Appendices Part 4

Comments INDIV-200s

From: ARCF_SEIS <ARCF_SEIS@usace.army.mil>
Sent: Wednesday, January 31, 2024 1:14 PM
To: Sutton, Drew; ARCF_SEIS
Cc: publiccommentARCF16@water.ca.gov
Subject: [EXT] FW: [Non-DoD Source] American River Common Features (ARCF) 2016 Draft Supplemental Environmental Impact Statement/Subsequent Environmental Impact Report (SEIS/SEIR) – December 2023 Report and Appendices

Figure 17-1: Combined Probability of Poor Performance for Without Project Conditions

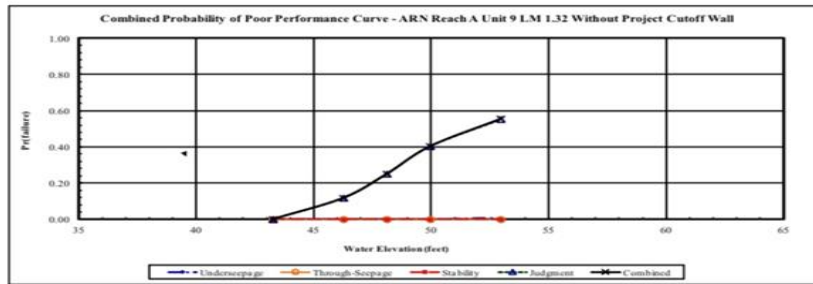
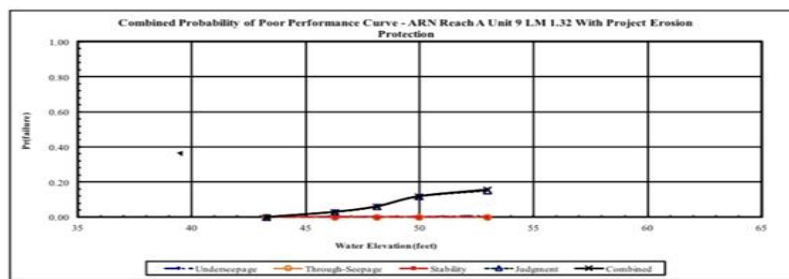
2. Section 17.0, Probabilistic Analyses, provides a “probabilistic evaluation” of each index point to evaluate uncertainty in model parameters regarding seepage and slope stability. This section provides graphs of probable levee performance without the project and with the project. Figures 17-1 and 17-2 supposedly show the improvement of performance of the levee at Howe Avenue. However, Figure 17-1 shows the curve without the project also does not include the cutoff wall, whereas Figure 17-2 curve includes the cutoff wall. This is therefore an “apples to oranges” comparison of the need for erosion protection.

Figure 10-1: ARN Reach A U9 LM 1.32 Without Project Analyses Results

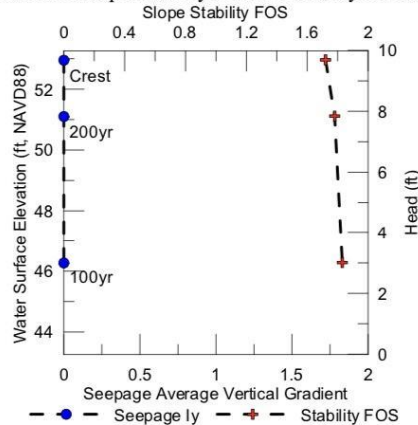
1. Geotechnical Report, 2016 GRR, Figure 10-1, Appendices page 705, in the text above Figure 10-1, reads: "As no seepage and stability deficiencies exist, no further improvements are recommended." Therefore, the Geotechnical Report refutes the need for erosion protection at Howe Avenue to prevent seepage.

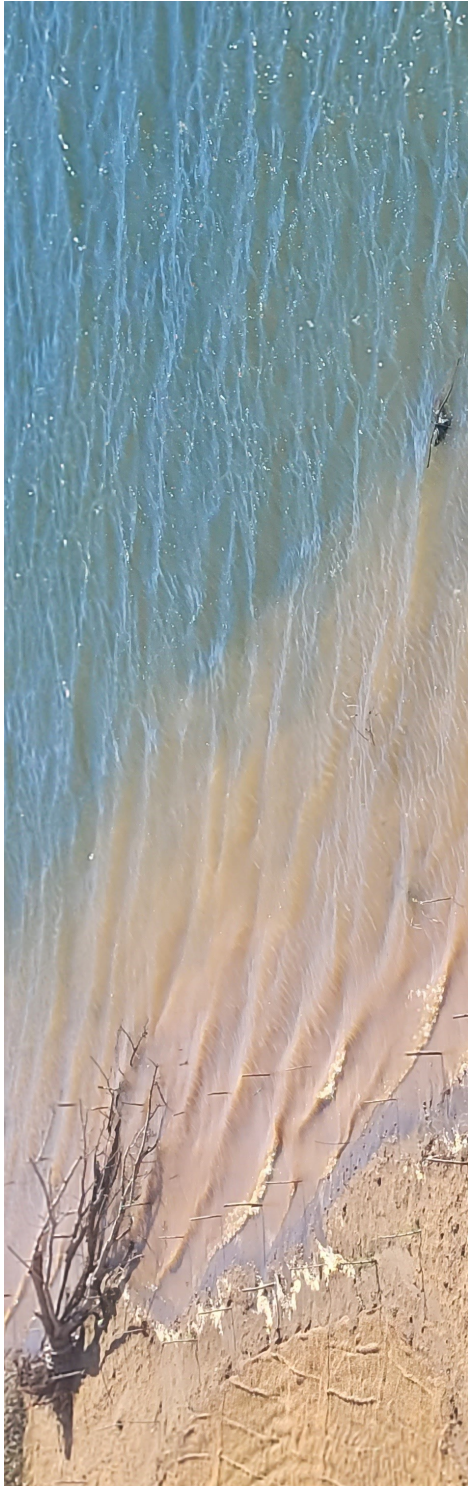
Photo of new Contract 2 soil surface being rapidly washed away by rain and river waves. Again, this level of erosion is never seen in a natural intact bank.

Figure 3.5.2-9. American River Erosion Contract 3B South Site 4-1 Details

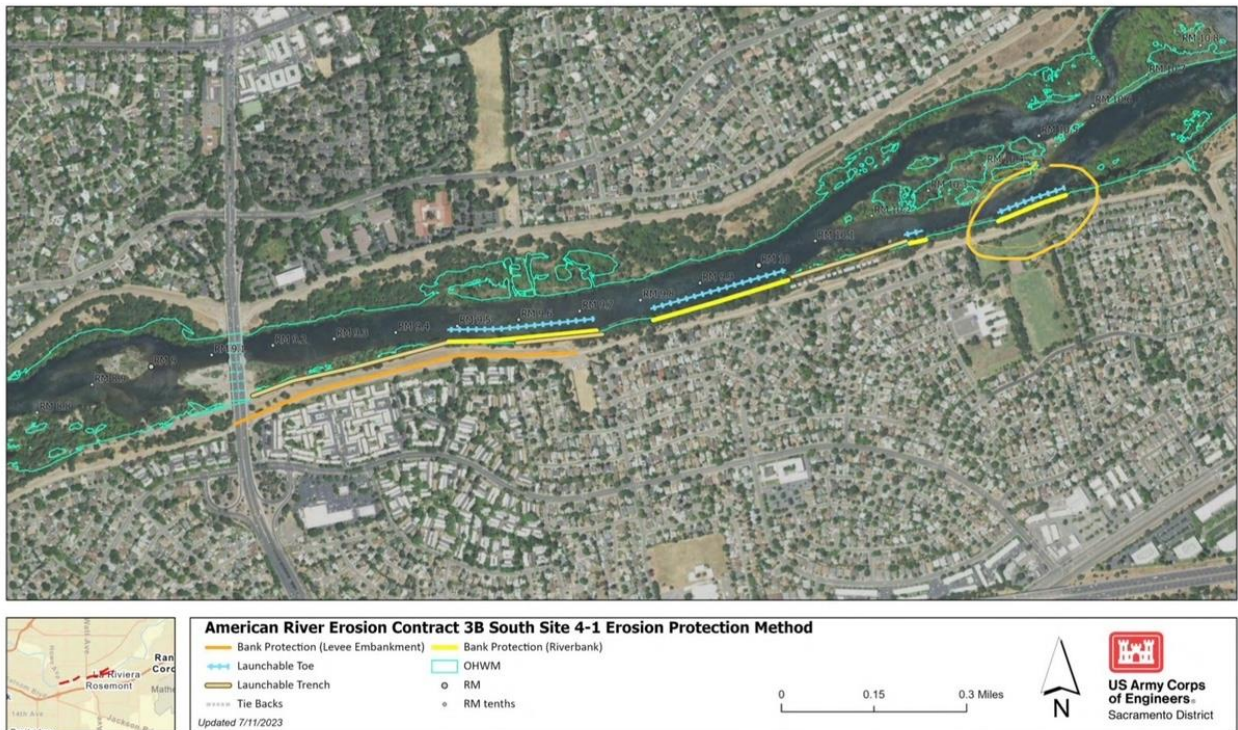
My name is William Brattain, P.E., and I am a resident near the proposed work along the Lower American River. I am a California-licensed civil engineer and am a retired former Water Resource Control Engineer who worked for the California Central Valley Water Board for 25 years. I am submitting comments on the *Draft American River Common Features, 2016 Flood Risk Management Project, Supplemental Environmental Impact Statement/Subsequent Environmental Impact Report XIV* (Draft SEIR), and in particular, for the proposed work under Contract 3B at River Mile 10.4-10.5, Larchmont Park. I have already submitted five sets of previous comments on Draft SEIR that focused on the flow velocity of the river, the distance of the heritage oak trees at the Larchmont Park from the base of the levee, the riverbank thickness at Larchmont Park River Mile 10.4-10.5, compliance with the federal Wild and Scenic Rivers Act, and the erosion work done under previous contracts during the summer of 2022. The comments in this submittal focus on the lack of erosion threat to the levee at River Mile 10.4-10.5 south, Larchmont Park, which is circled on the following figure:

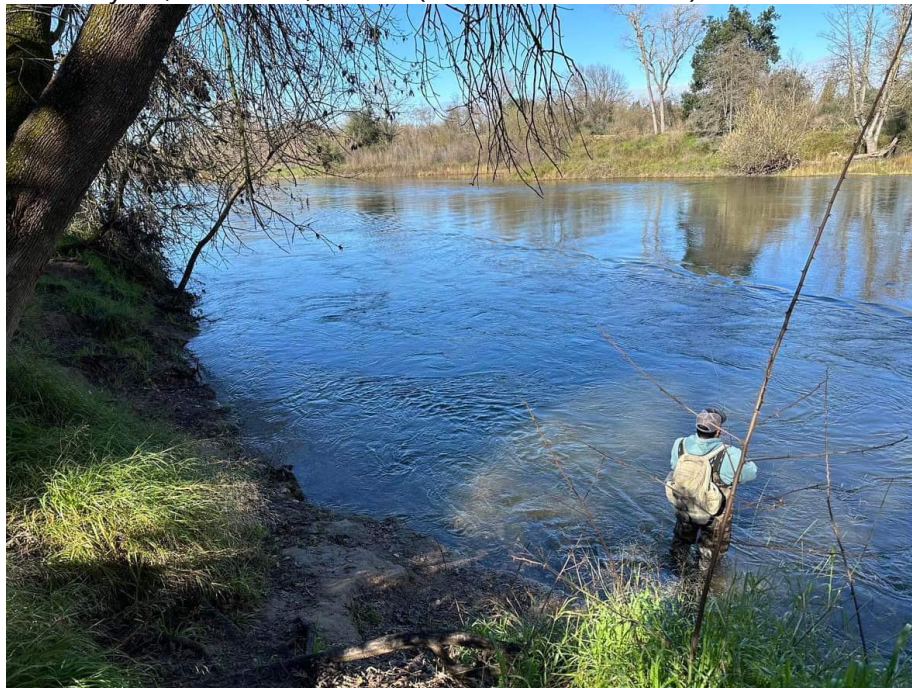
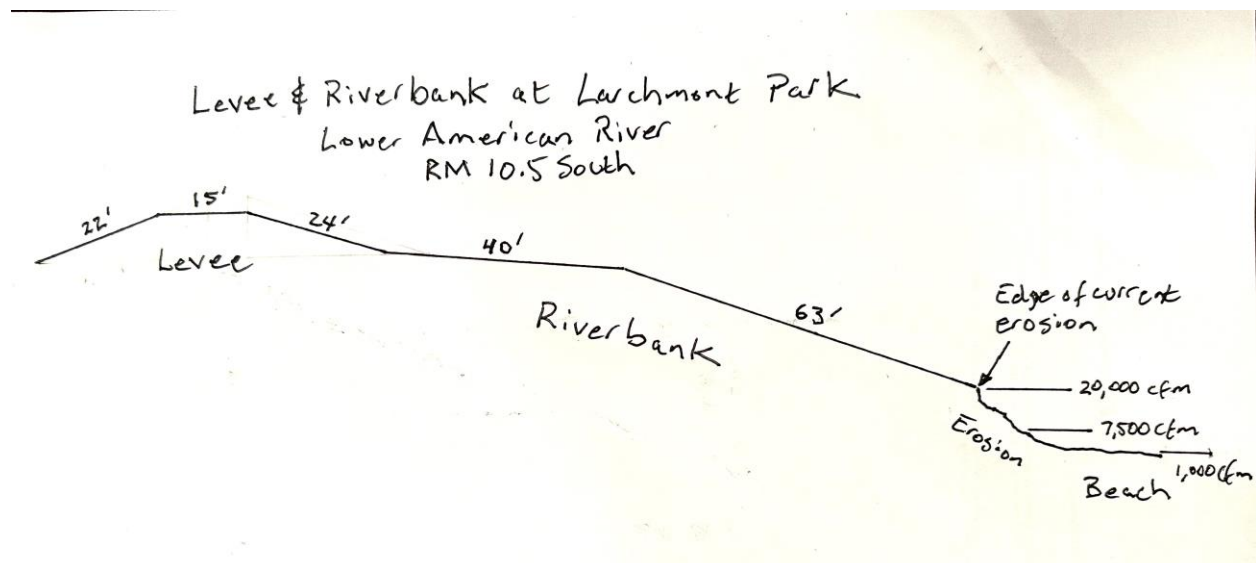
The following are pictures of the river at River Mile 10.5 South at the same location at several different flow rates. The first is today, February 18, 2024 at a flow of 7,500 cfs. The second is from December 16, 2016 at a flow rate of 34,000 cfs. The third is from February 10, 2017 at a flow rate of 82,000 cfs. In each case there is no indication that erosion is occurring:

Figure 3.5.2-9. American River Erosion Contract 3B South Site 4-1 Details

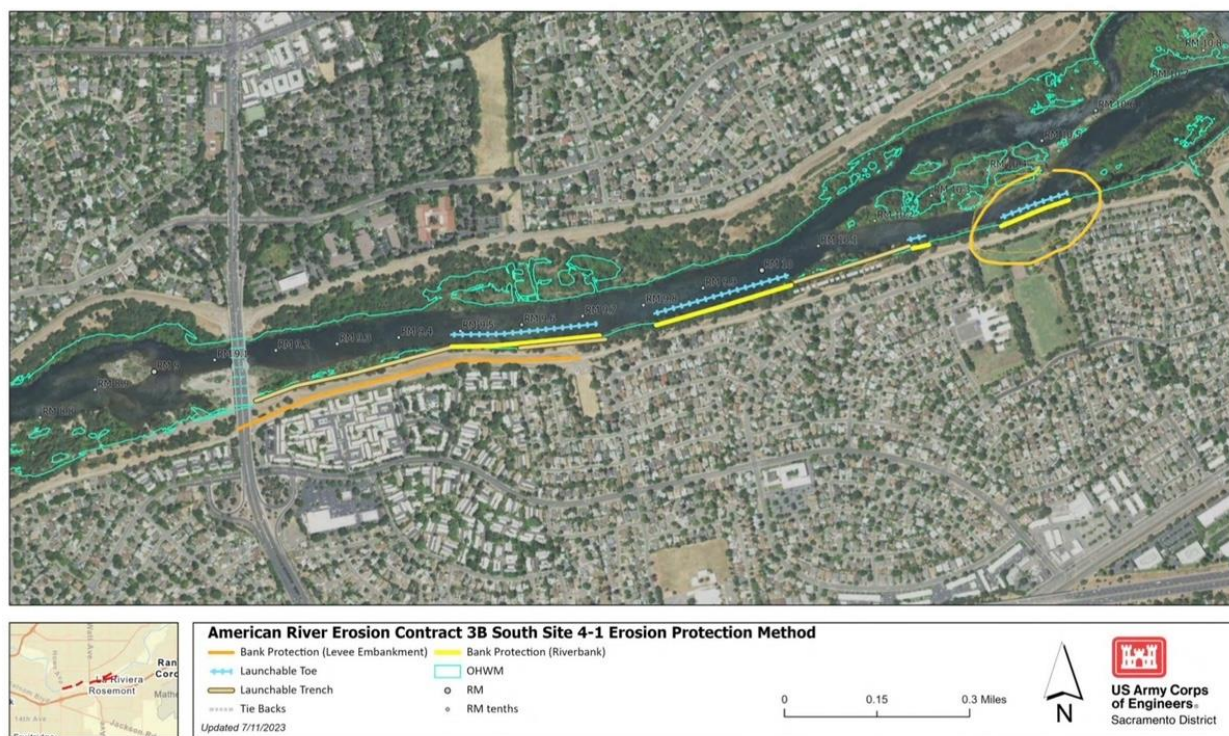
My name is William Brattain, P.E., and I am a resident near the proposed work along the Lower American River. I am a California-licensed civil engineer and am a retired former Water Resource Control Engineer who worked for the California Central Valley Water Board for 25 years. I am submitting comments on the *Draft American River Common Features, 2016 Flood Risk Management Project, Supplemental Environmental Impact Statement/Subsequent Environmental Impact Report XIV* (Draft SEIR), and in particular, for the proposed work under Contract 3B at River Mile 10.4-10.5, Larchmont Park. I have already submitted six sets of previous comments on Draft SEIR that focused on the flow velocity of the river, the distance of the heritage oak trees at the Larchmont Park from the base of the levee, the riverbank thickness at Larchmont Park River Mile 10.4-10.5, compliance with the federal Wild and Scenic Rivers Act, the erosion work done under previous contracts during the summer of 2022, and the lack of erosion threat to the levee at River Mile 10.4-10.5 south, Larchmont Park. The comments in this submittal focus on the regulations for levee certification and why the proposed work at River Mile 10.4-10.5 south at Larchmont Park (circled on the following map) is far beyond what is needed to meet the requirements in those regulations. These comments also focus on why the proposed work will make the levee system less safe during a period of relatively high vulnerability before the future work to raise Folsom Dam is completed.

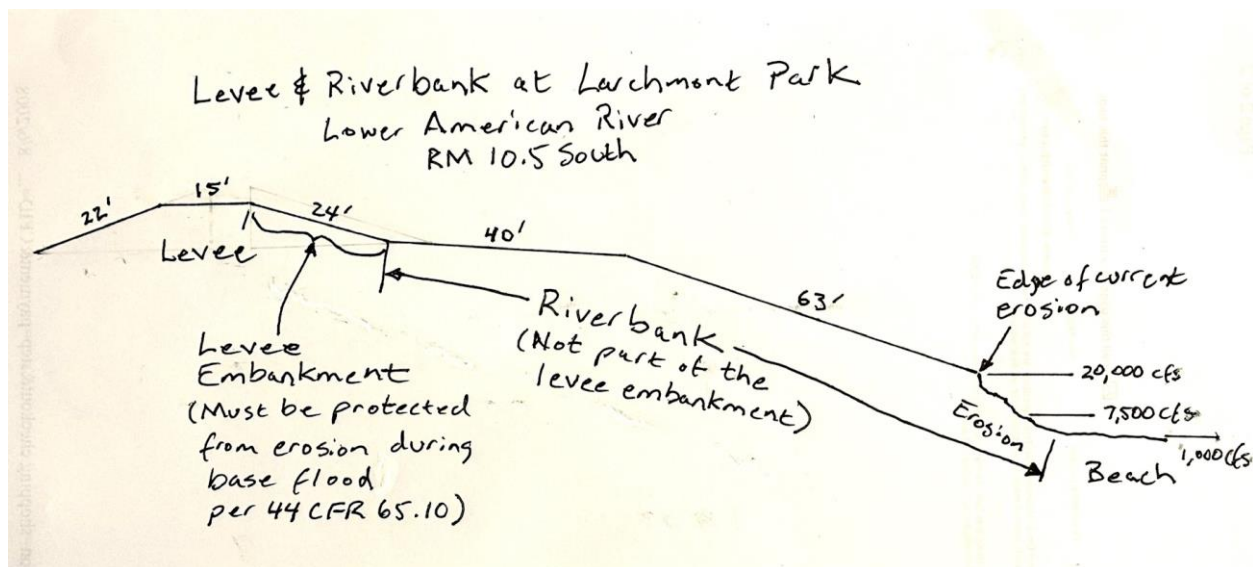
The following is a to-scale cross section of the levee and the riverbank at Lower American River Mile 10.5 south (RM 10.5 south) at Larchmont Park. The levee embankment requiring protection from the base flood under 44 CFR 65.10 is the 24-foot long interior sloped section of the levee, as noted in the figure.

In order to obtain accreditation, the levee owner only needs to certify that the levee embankment is protected from erosion during the base flood. It is not necessary to also demonstrate that the entire length of the riverbank is protected from erosion; however, erosion of the riverbank should not be allowed to threaten the stability of the levee. It should be expected that some erosion will occur at the base of the riverbank (a.k.a., the streambank) as this is a natural process for any river. In the case of the levee and riverbank at RM 10.5 south, there is over 100 feet of densely-vegetated riverbank between where the erosion has occurred over the past many decades to centuries, but this erosion is not threatening the levee and should not be considered to be erosion of the levee embankment that would violate the 44 CFR 65.10 requirements and prevent certification.

Figure 3: Map of Index Point Locations Considered in Geotechnical Report. Only 2 index points are used for the entire Lower American River

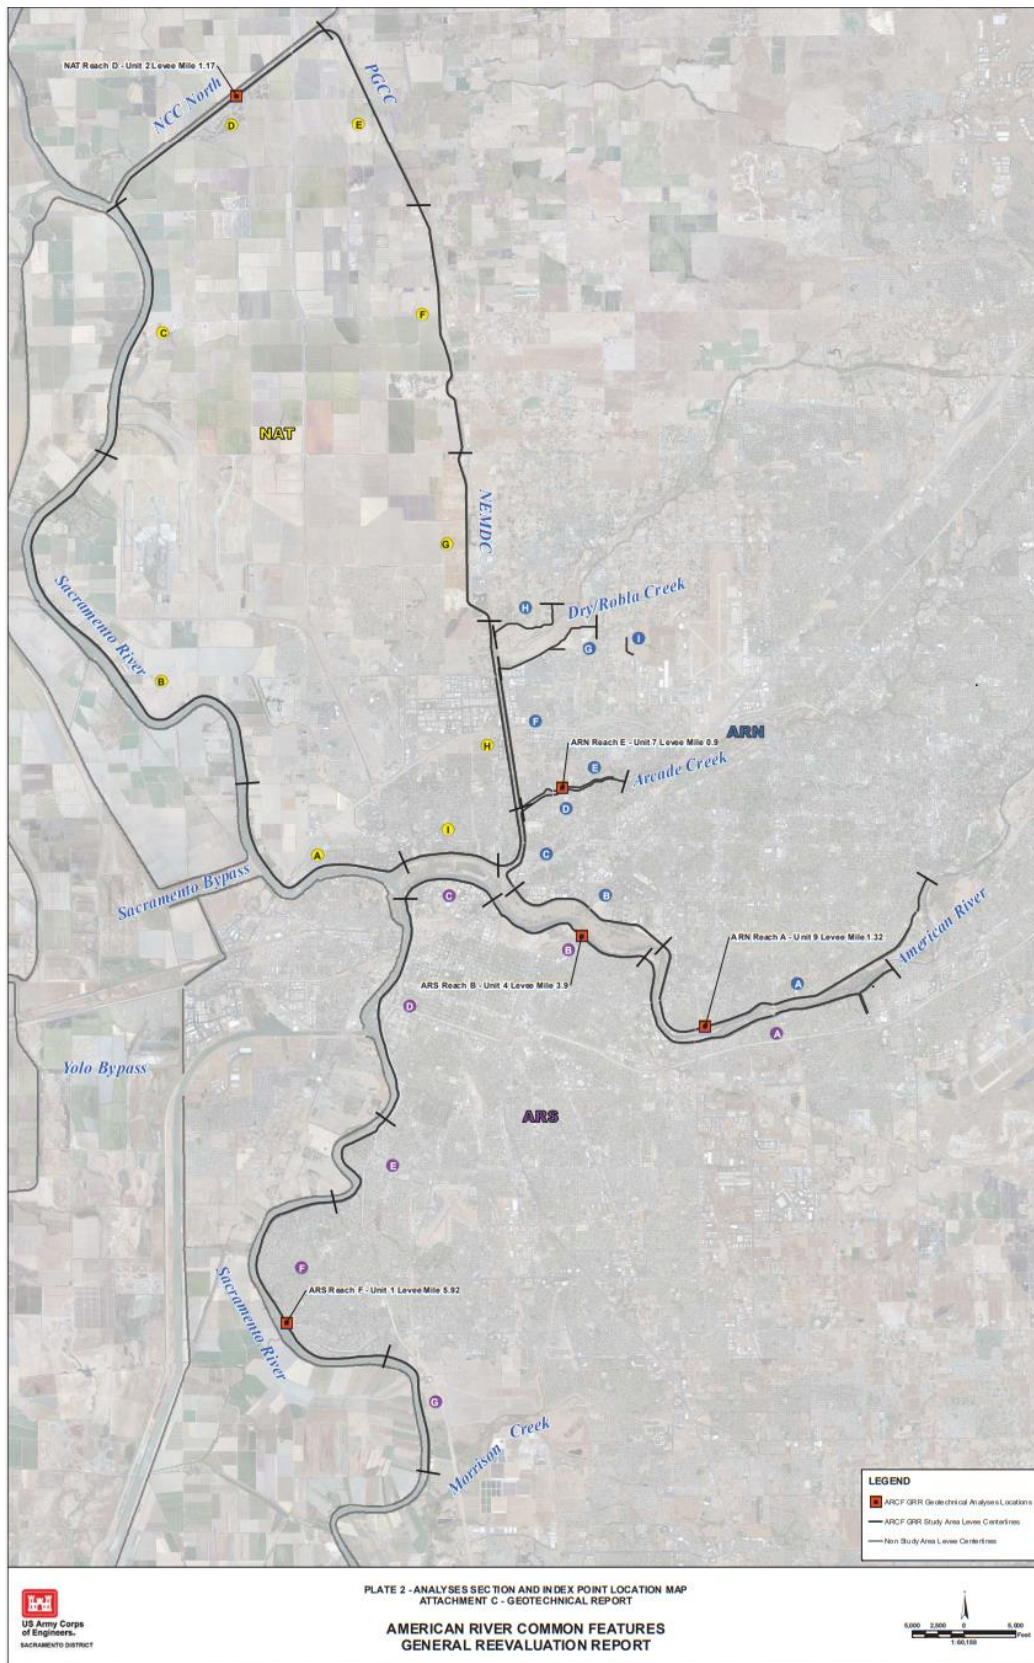
7 The use of a boring near Howe Avenue Bridge to justify work two miles upstream is especially egregious because the *Erosion Protection Report* indicates that the banks upstream of Howe Avenue consist of fundamentally different bed materials than the banks downstream of Howe Avenue. According to the *Erosion Protection Report*, the area between river mile 6.6-7.5 contains “broader areas of scour where the formation is likely more widely exposed in the channel bed or lies concealed beneath a thin cover of active channel only a few feet thick.”⁴³ This unit “contains no bank resistance to lateral erosion and will not contribute to levee stability.”⁴⁴ This is, in other words, an area with highly erodible bed materials. However, the area upstream of Howe Avenue, especially near the entrance of SARA Park (left bank river mile 10.0-10.3) where the Corps proposes to install a launchable rock trench and launchable rock toe, contains significant amounts of erosion-resistant clay hardpan, which the technical documents refer to as the “Pleistocene Fair Oaks Formation.”⁴⁵ The only modeling results USACE provides for the area containing Pleistocene Fair Oaks Formation, between river mile 7 and river mile 11, indicate that “for all the flows simulated the sheer stress in the reach with locally exposed hard material is below the critical stress for erosion of moderately resistant material (clay and cemented sand with silt). **Therefore, significant scour below this erosion resistant material/surface is not anticipated.**”⁴⁶

Figure 2-8: Velocities in the Lower American River at a discharge of 160,000 cfs

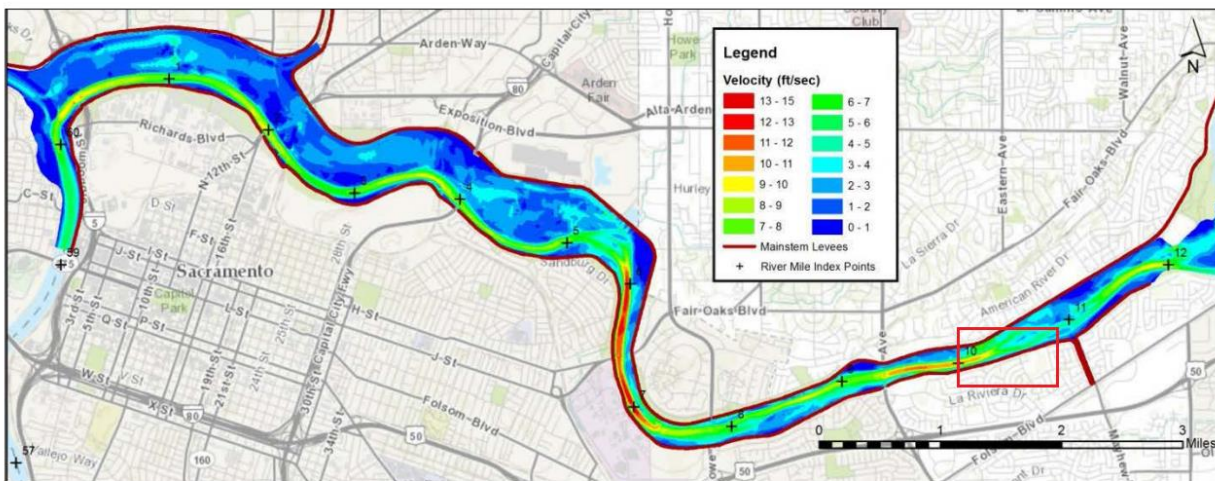
low on levee at 200 year flood flows, 160,000 cfs, to cause serious damage.⁶⁰ For left bank river mile 10.0-10.3, where USACE proposes two launchable rock toes and a launchable rock trench, two of the experts cited low velocities on levee and upper bank, with one noting “water velocities low on levee face at 160 kcfs.”⁶¹ For left bank river mile 10.4-10.5, an expert stated that water velocities were low on the levee at 160 kcfs.⁶²

Such observations are consistent with the velocity contour maps in the *General Reevaluation Report*.⁶³ While these maps show that at 160,000 cfs velocities along the some of the LAR’s banks can reach a significant velocity of 12-13 ft/sec, between left bank river miles 10 and 11, which comprises most of Contract 3B South, estimated velocities along the banks during a 200 year, 160,000 cfs event only range from 0-1 ft/sec to 6-7 ft/sec. At these velocities
